SCHNEIDER
Schneider AG DUAL GmbH
Silvastraße 1
D-86842 TÜRKHEIM

Service - Info

Unit : Chassis TV 9.xx

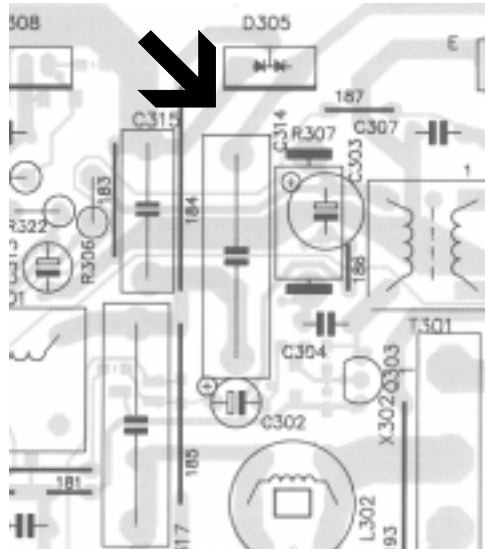
Verticale line in the right side of the picture

To remove this problem, the soldering rivet Z 601 has to be soldered again

Concern: Rectifier / Chassis TV 9.XX (pos. D 102)

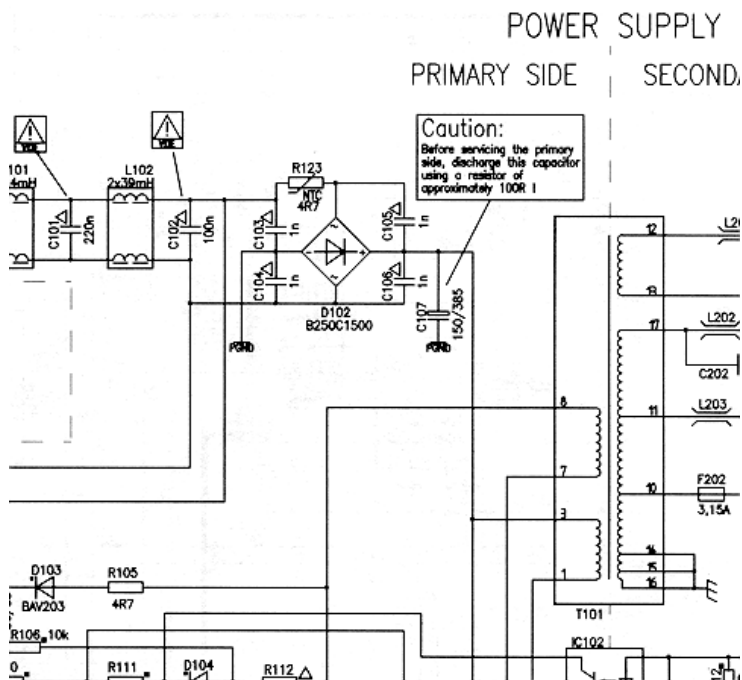
In case of service the rectifier in position D 102 has to be replaced by the replacement version alike the below declared sketches.

Rectifier „ old “ version

Rectifier „ new “ version

Spare part number rectifier „ new “ version : 0038833

Circuit diagramm / wiring side IC 701:

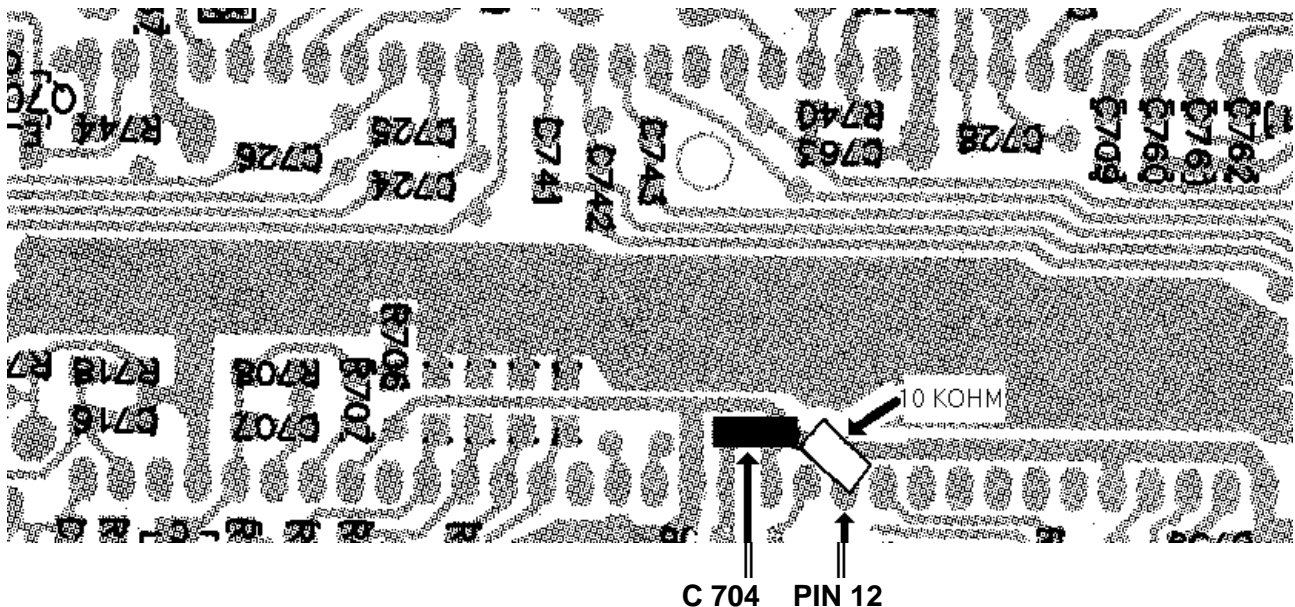
Performance improvement concerning IC VDP 31XX (IC701)

One 10k Ω chip resistor has to be componented additional between pin 12 / IC 701 and the chip capacitor C 704 (use the printed line to Pin 5 and Pin 1 from IC 701).

Part number chip resistor 10 k Ω : 0038967

Main p.c.b. / IC 701 (wiring side):

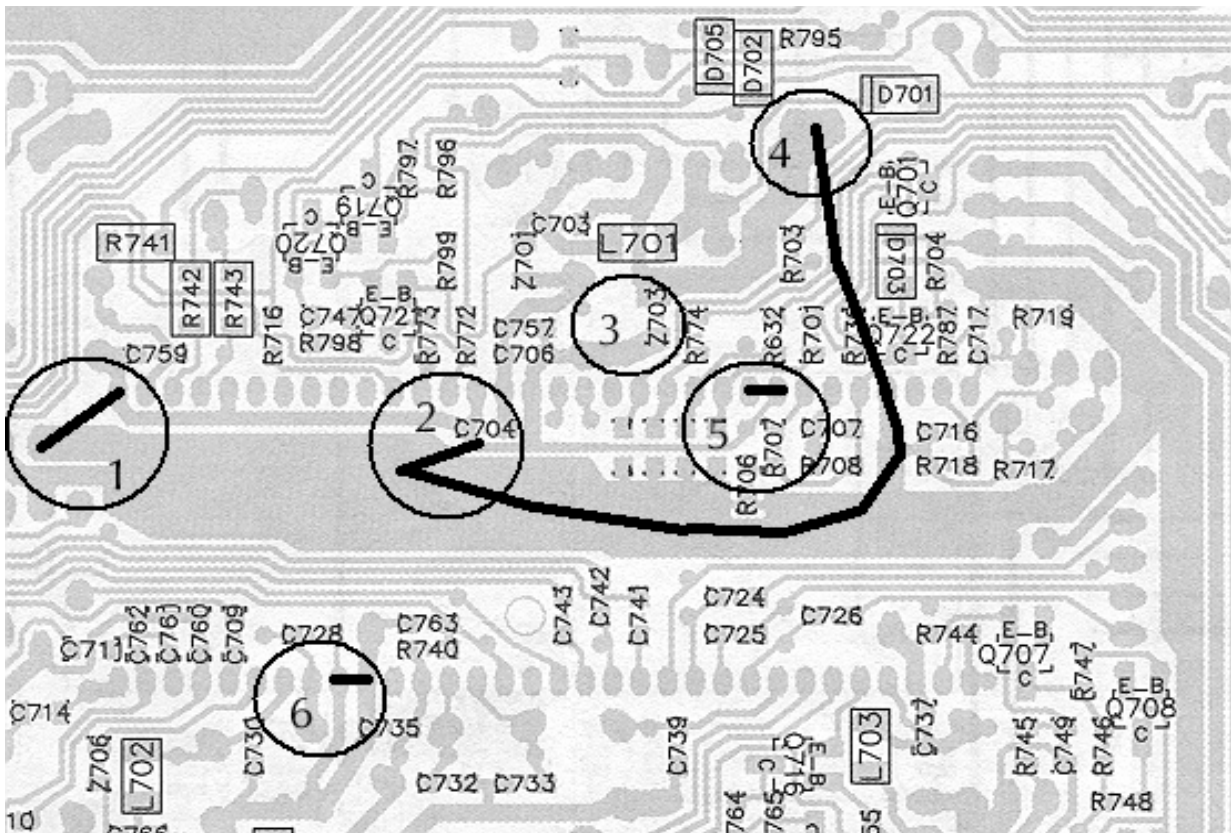
Concern: Improvement of the immunity from static discharge.

| ❶ Short circuit connection Pin 1 IC 701 ⇒ ground | ❷ Short circuit connection C 704 ⇒ ground |
| ❸ Chip „Z 703“ has to be removed | ❹ Short circuit connection, laying according to below declared diagram (lenght 60 mm) |
| ❺ Short circuit connection IC 701

Pin 24 ⇒ Pin 25 | ❻ Short circuit connection IC 701
Pin 55 ⇒ Pin 56 |

Attention: The modification 1, 2 and 5 are already integrated up to board number 0109040.

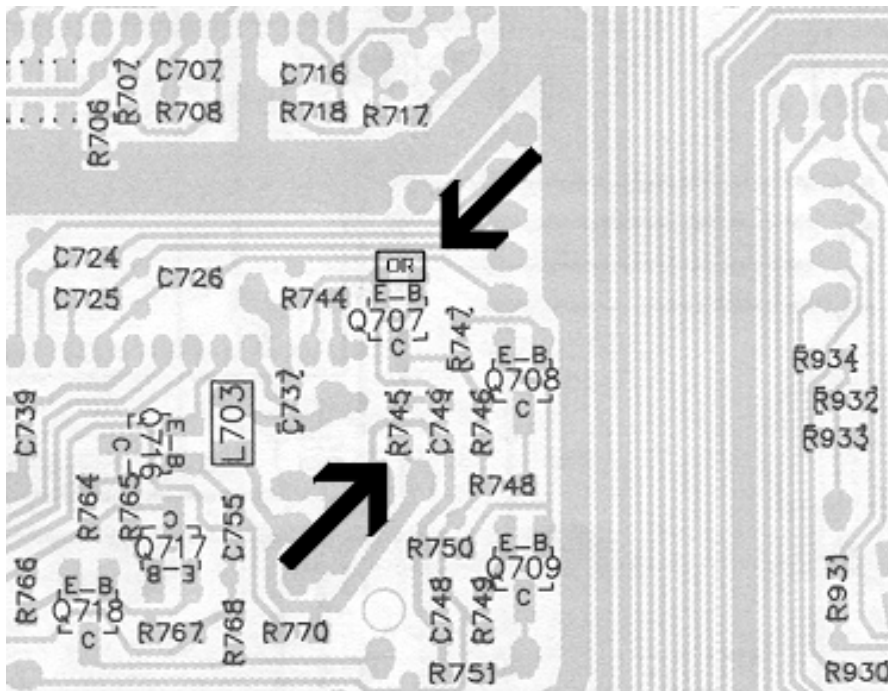
Concern: Vertical stripes at the right side behind the OSD

- The chip resistor in position CR 745 (100 Ω) has to be removed and replaced by a 0 Ω version
- Between emitter and basis from transistor a 0 Ω chip resistor has to be componentd additional (like illustration)

Part number chip resistor 0 Ω : 0100060

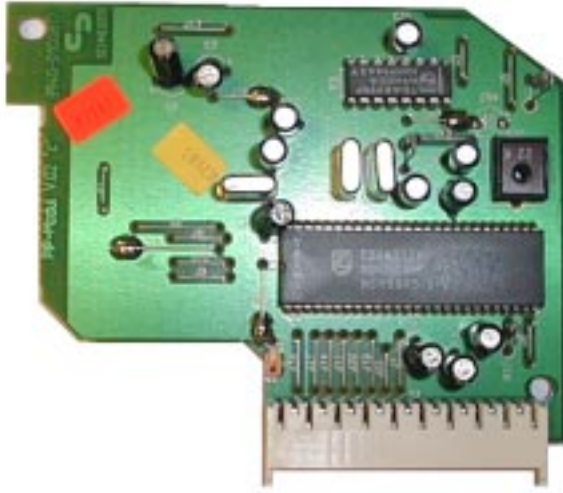
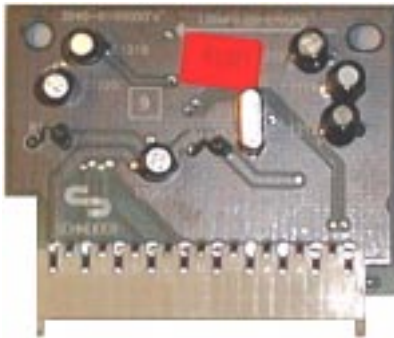
Chassis	TV 9.3 in connection with picture tube type W 66 ECK 001X13
Concern:	Unsynchronizing PIP picture (PIP-module version 3)

PIP-module version 1 and 2 : Modification not necessary

PIP-module version 3: The Chip resistor in position R 1204 has to be removed and replaced by a 270 Ohm / 150V chip resistor. The chip diode BZT55C in position D1202 has to be componented in addition.

Spare part number: Chip resistor 270 Ohm	0100090
Chip diode BZT55C	0100683
